## PLANNING REPORT Architectural Review Board

# **83 S. High Street 22-149INF**

Proposal Informal review and feedback for the addition and remodeling of an existing two-

story building in the Historic District.

Proposed roof plan (north is up)

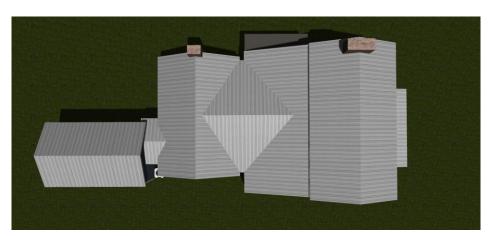
PDL notes the hyphens between the historic saltbox roof and the new structure are approximately 12 inches deep by 24 inches wide. They encourage larger hyphens to make the break between the historic structure and

the addition more substantial, in accordance with Guidelines Section 4.12C, where a break or reveal is needed between the two. They also recommend the cricket and the eaves connecting the saltbox and the new addition be lowered to lessen the visual impact on the saltbox. This would be more in accordance with Guidelines Section 4.12H. PDL also notes that the laundry room bump out on the north elevation, adjacent to the attached garage (small offset jog), could be better integrated. Overall, PDL recommends the addition be further simplified in order to remain clearly distinguishable from the original structure, as noted in Guidelines Section 4.12A.
